10 CFR 50.55a
L-2014-105
April 14, 2014

Re: Turkey Point Unit 3
Docket No. 50-250
Inservice Inspection Plan - Fifth Inspection Interval
Unit 3 Relief Request No. 1 – Response to Follow-up Request for Additional
Information

Turkey Point Unit 3
Fifth Inspection Interval - Relief Request No. 1
Response to Follow-up Request for Additional Information

Figure 1: Temperature Dependence of the Charpy "V" Notch Impact Properties of SA-216 Gr. WCC, Heat 4312. (Sulfur content = 0.013 wt. %) [4]

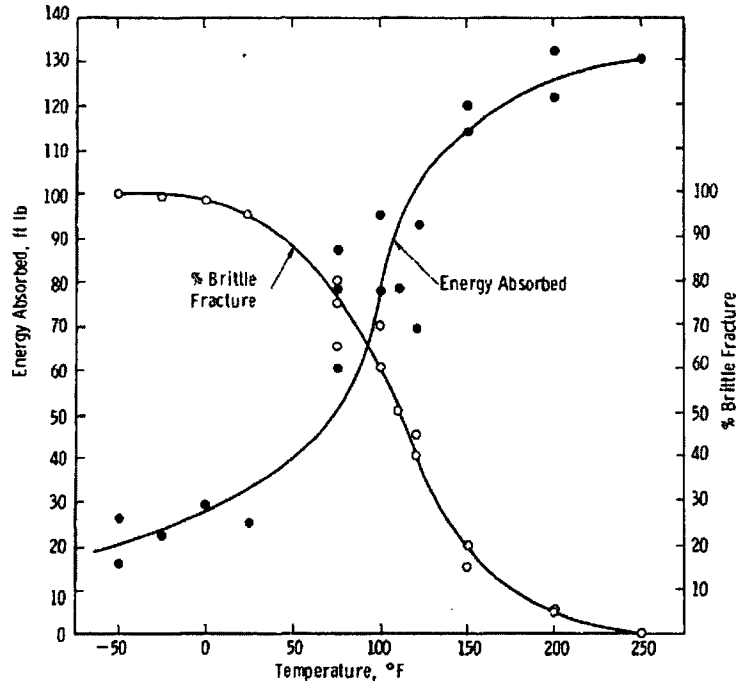
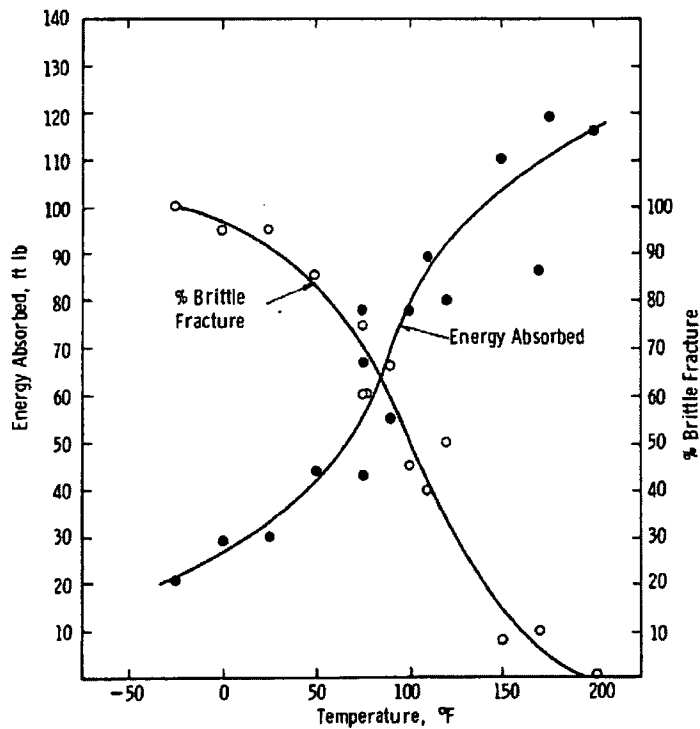
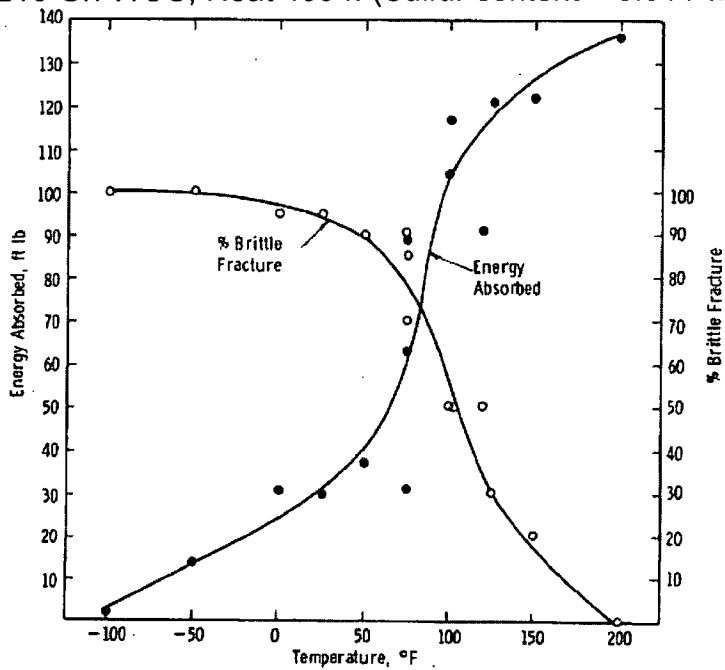
In response to RAI 3, Item b, FPL provided a graph of fracture toughness (K_{IC}) versus temperature for the Turkey Point, Unit 3 pressurizer bottom head material. However, both of the heater sleeve flaw evaluations referenced in the relief request (Ref. 1, 2) used elastic-plastic fracture mechanics (EPFM) techniques to demonstrate stability of the final flaw, because the American Society of Mechanical Engineers, Boiler and Pressure Vessel Code (ASME Code), Section XI linear elastic fracture mechanics (LEFM) acceptance criteria were not met. This is specifically noted in Section 6.3.3.2 of Reference 3. Also in Reference 2, EPFM was used as the basis for accepting the final flaws.

Therefore, the staff requests that FPL (1) provide the material resistance (J-R) curve for the Turkey Point, Unit 3 pressurizer bottom head material (2) justify the use of the J-R curve in this application if it is not based on test data, and (3) demonstrate that the J-R curve is bounded by (i.e., provides equivalent or greater resistance to fracture) the J-R curve used in Refs 1 and 2.

There are no plant specific data available for the SA-216 Gr. WCC cast steel used in the Turkey Point pressurizer heads. However, a number of heats of the same type of material were tested in [4], and full Charpy curves were obtained on three of them. These Charpy curves, shown in Figure 1 through Figure 3, demonstrate that the upper shelf Charpy energy is at least 100 ft-lb for each heat. Tests also demonstrate that the sulfur level for these materials is typically less than 0.018 weight percent. Therefore, the Regulatory Guide equations used in [3] for the previous evaluation are directly applicable.

Based on these evaluations, the model used in [1 and 3] is more limiting than a similar model based on the material of the Turkey Point Pressurizer head.
